## PRODUCT INFORMATION NOTIFICATION

**PIN:** PIN200302

**Subject:** Ejector Pin Mark Change for Select 32-LQFP Package Assembled at TFME

# Select 32-LQFP Package Ejector Pin Mark Change

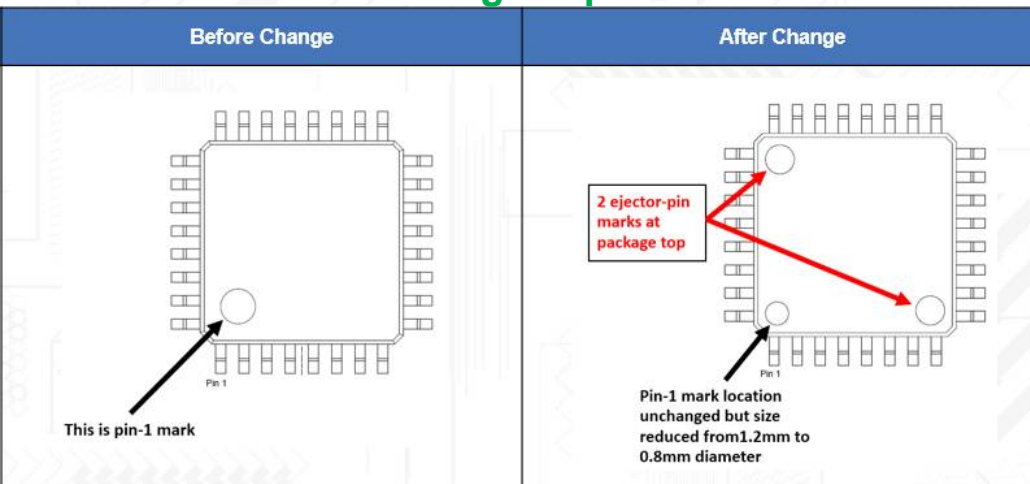
## Changing Points - Pin 1 size, number of ejector pins & ejector pin location

- a) Pin 1 size reduced from 1.2mm diameter to 0.8mm.
- b) At package top surface, added 2 ejector pin marks.
- c) At package bottom surface, changed from 1 ejector pin mark (2.5mm) at the center to 2 smaller ejector pin marks (1.0mm) at the corners

## Marking Position Shift

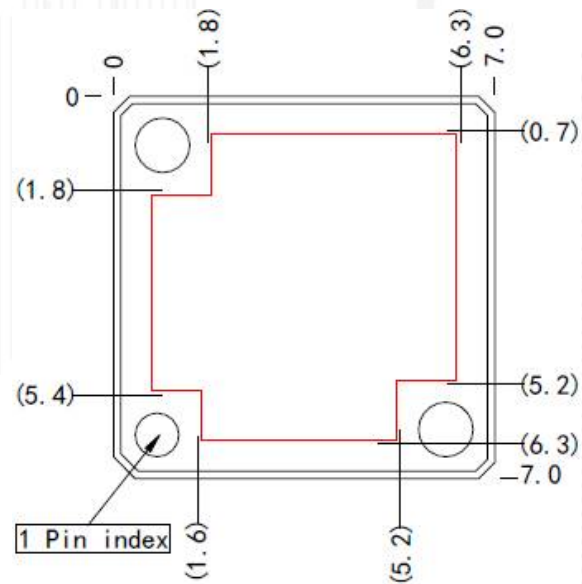
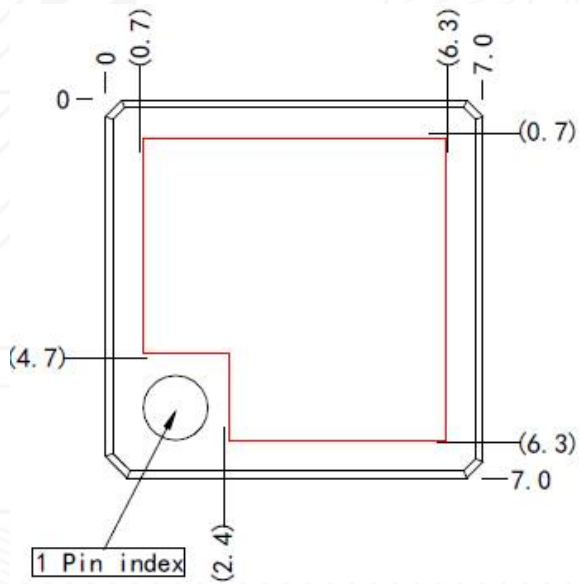
Picture below shows on revised marking area for LQFP32 to avoid the e-pin mark at package top.
